Company	Trenz Electronic GmbH
PCN Number	PCN-20250326
Title	TEB0724-02 FTDI EEPROM Update
Subject	FTDI EEPROM
Issue Date	2025-03-26

2.1 #1 FTDI EEPROM AMD-Licence key (MISC1).

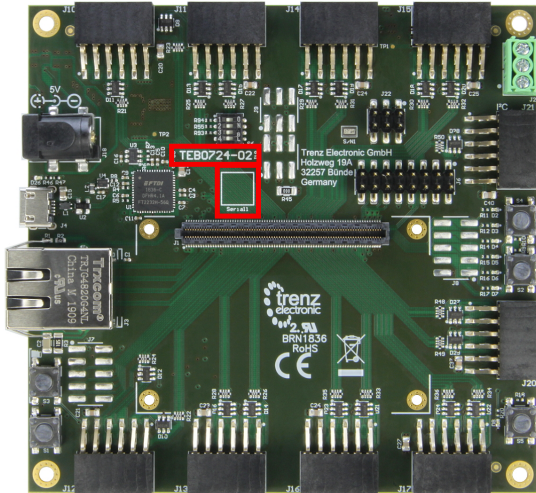
Type: Firmware change

Reason: Change according to FTDI programming method released by AMD with Tool Version 2022.2 and newer (UG980 - Chapter: Programming FTDI Devices for Vivado Hardware Manager Support).

Impact: AMD Licence key is compatible with AMD Tools greater and equal 2017.1 release. Programmer will be identified as Xilinx device with prefix 'TE' ,see [AMD FTDI JTAG Programmer#IdentificationofAMD/TrenzLicence](https://wiki.trenz-electronic.de/display/PD/AMD+FTDI+JTAG+Programmer#AMDFTDIJTAGProgrammer-IdentificationofAMD/TrenzLicence)¹
